Subject: Eaton FR Transmission

Models Affected: Specific Freightliner Cascadia, Business Class M2, 108SD, and 114SD vehicles and Western Star 4700 vehicles manufactured January 4, 2015, through April 24, 2015, with certain Eaton FR 10-speed manual transmissions.

November 2015
FL693A
NHTSA #15V-617

Fig. 1, Spacer Identification

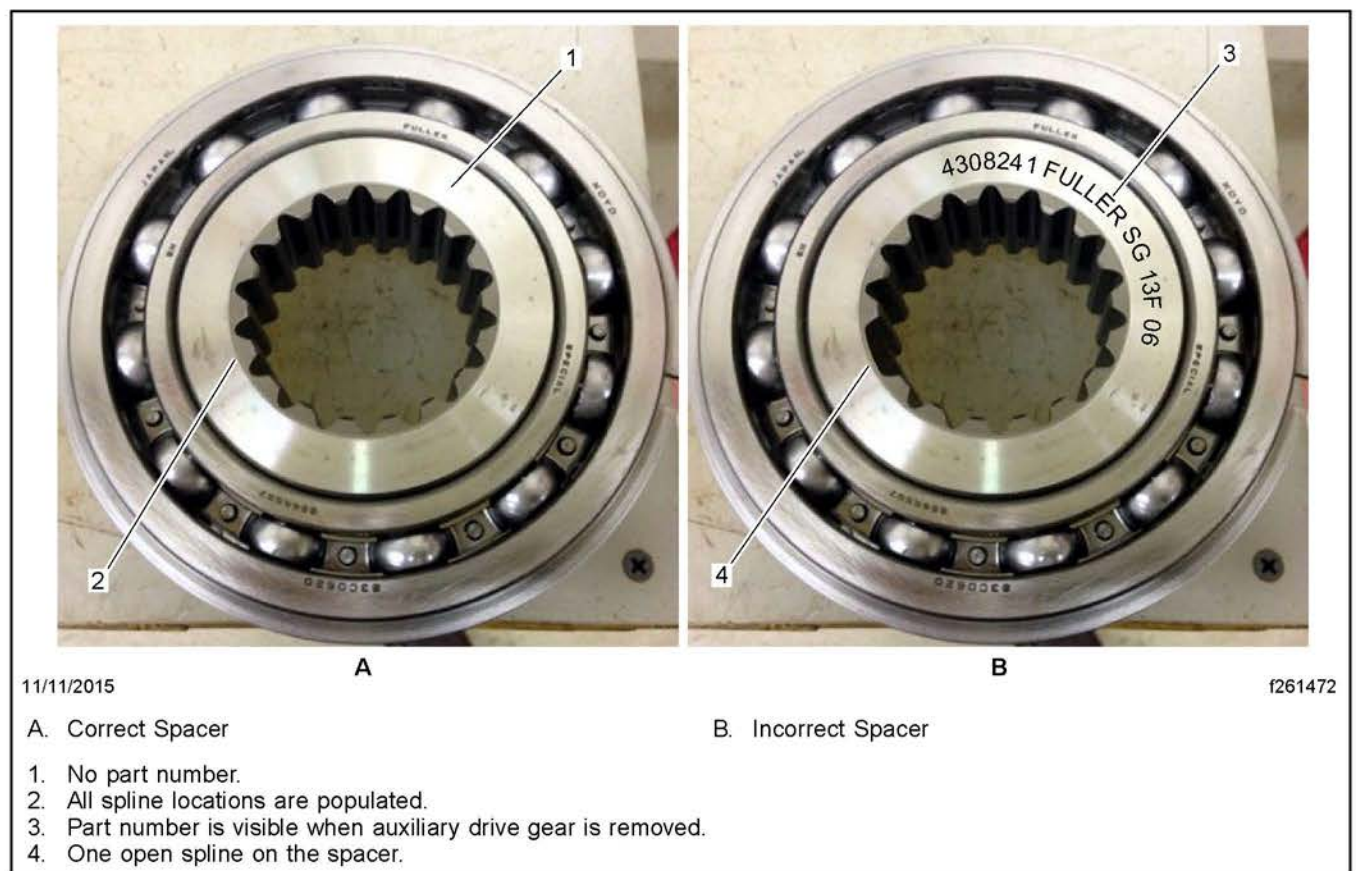
The correct spacer does not have an open spline or a visible part number printed on it. **Fig. 1**, Ref A shows the correct spacer, and Ref B shows the incorrect spacer. Submit photographs to RTW for verification regardless of the spacer installed.

If the spacer has all the possible splines engaged with the mainshaft and no visible part number, go to step 20.

If the spacer has an open spline and the part number 4308241 is visible, go to step 19.
